Portsmouth City Council Dunsbury Hill Farm

Stage 1 Road Safety Audit

August 2011

Problem Locations - Annotated Plans

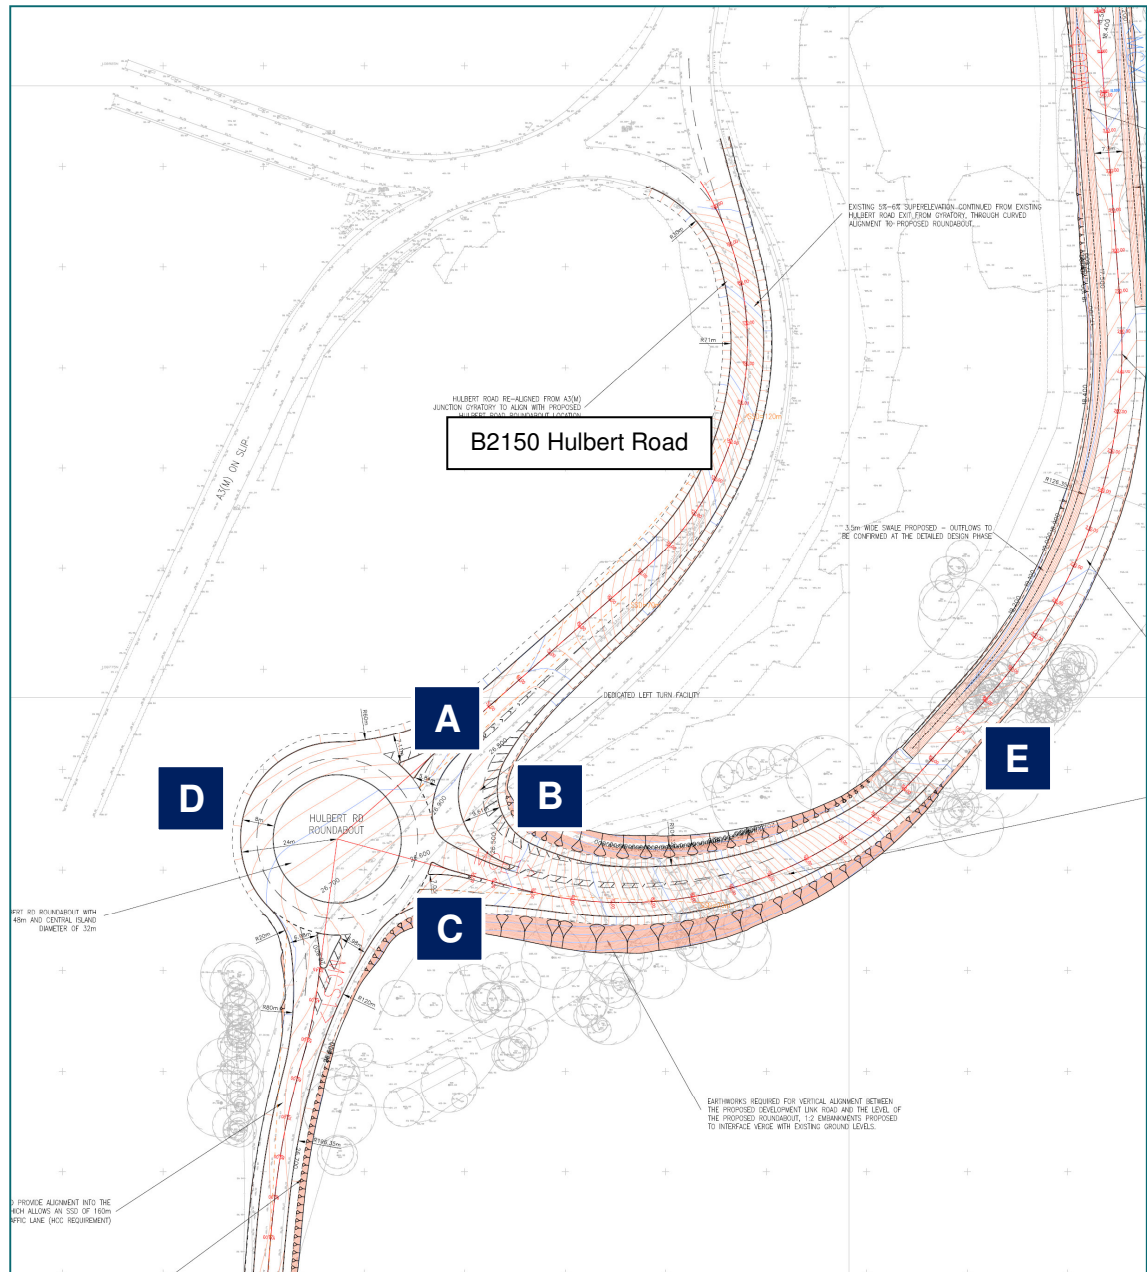
PROBLEM A

Location: Proposed roundabout on B2150 Hulbert Road

Summary: High speed downhill approach to roundabout

Vehicles approaching the proposed roundabout from the A3(M) Junction 3 gyratory will be on a downhill gradient. During the site visit, the Audit Team were of the opinion that the perceived speeds of southbound vehicles appeared to be in line with the recorded 85th percentile speeds and confirmed concerns about how these users would negotiate the proposed roundabout. Specific concerns at this juncture would be vehicles losing control when entering the roundabout at high speeds or failing to stop and colliding with circulating vehicles.

PROBLEM B

Location: Proposed roundabout on B2150 Hulbert Road

Summary: High speed downhill approach to dedicated left-turn lane

The dedicated left turn facility for users entering the development has a low radius and would be approached on a downhill gradient. If users are not given a clear message about the low speeds needed to travel round this bend, they will be more likely to fail to negotiate it safely. This could lead to either single vehicle loss-of-control accidents or collisions with other vehicles exiting the roundabout.

PROBLEM C

Location: Proposed roundabout on B2150 Hulbert Road

Summary: High flows along Hulbert Road may lead to queuing and driver frustration

Hulbert Road currently appears to carry a steady flow of traffic. Once the proposed roundabout is introduced it is possible that this steady flow along Hulbert Road will be predominant and will restrict entry to the roundabout for vehicles approaching from the Dunsbury Hill Farm development. It is particularly noticeable in the PM peak future traffic flows (Figure 3.9) that only an estimated 42 vehicles would turn right into the development, thus providing few gaps between the estimated 669 vehicles continuing from north to south on Hulbert Road. This imbalance of flows could lead to queuing at the exit from the development (1015 vehicles are forecast to be exiting in the PM peak) and resulting driver frustration may increase the likelihood of drivers choosing inappropriate gaps in which to enter the roundabout. This could lead to vehicle-to-vehicle collisions in the circulatory carriageway.

PROBLEM D

Location: Proposed roundabout on B2150 Hulbert Road

Summary: Offset roundabout may lead to problems related to vehicle paths

The proposed roundabout is offset from the existing Hulbert Road alignment. This creates a roundabout layout with arms in close proximity to each other which may compromise the achievement of appropriate approach geometry and entry path curvature. This type of layout can also lead to largely untrafficked areas of the circulatory carriageway where debris can gather and cause problems, particularly for motorcyclists and pedal cyclists.

PROBLEM E

Location: Approximate Chainage 170 on MCE1 Main Development Alignment

Summary: Short straight section between two curves may present a risk of loss-of-control accidents

At Ch.170 on the development link road (master alignment string MCE1) there is a short straight section, 24m long, in between two curves (100m and 130m radii). In extremes this type of horizontal alignment can lead to problems with users, particularly motorcyclists, being caught out by the short straight when they are expecting to continue steering around a curve. This can result in users losing control and leaving the carriageway. Despite the 30mph speed limit proposed for the development it is possible that motorcyclists could be travelling in excess of the posted speed limit.

PROBLEM G

Location: Existing Woolston Road Roundabout (western arm)

Summary: Entry geometry is unlikely to control entry speeds

The entry geometry for eastbound traffic leaving the development and entering the existing roundabout from its western arm appears unlikely to sufficiently encourage reduced entry speeds. Whilst not detailed on the drawings, it is understood that it is probable that this arm of the roundabout would only be used by buses, pedestrians and cyclists. There is still a concern however that, unless sufficient entry deflection is provided, buses entering the roundabout (or other vehicles if eventually permitted to do so) may do so faster than desired, potentially leading to collisions on the circulatory carriageway.

RECOMMENDATION

As the design is progressed, ensure that the proposed roundabout approach and entry geometry will sufficiently and physically encourage reduced speeds. Ensure that the road layout and the presence of the new roundabout is clear to approaching drivers in terms of signing and forward visibility, to further encourage them to approach and enter the roundabout at an appropriate speed.

RECOMMENDATION

Ensure that the horizontal alignment of the left turn facility is smooth and that the radius does not tighten as users proceed through the bend. Ensure that any superelevation is applied smoothly through the traffic lane. Ensure that the nature and layout of this left turn facility is clearly communicated to approaching drivers.

RECOMMENDATION

Review the traffic turning movements at the junction and the choice of a roundabout as the method of control. Seek a solution that provides a degree of balance of priority for all arms of the junction. If queuing is expected to occur on the approach from the development, ensure that forward visibility to any traffic queues is good.

RECOMMENDATION

Review the need for the roundabout to be offset from the Hulbert Road alignment by such a significant distance. Should this offset prove unavoidable, seek to amend the roundabout's geometry to minimise the potential for untrafficked areas within the circulatory carriageway while still ensuring that the geometry sufficiently controls entry speeds into the roundabout.

RECOMMENDATION

Amend the layout to remove the straight section, either through the use of transitions or by provision of a continuous curve.

RECOMMENDATION

Realign the nearside kerblines and splitter island to ensure that the approach and entry geometry sufficiently encourages reduced traffic speeds.
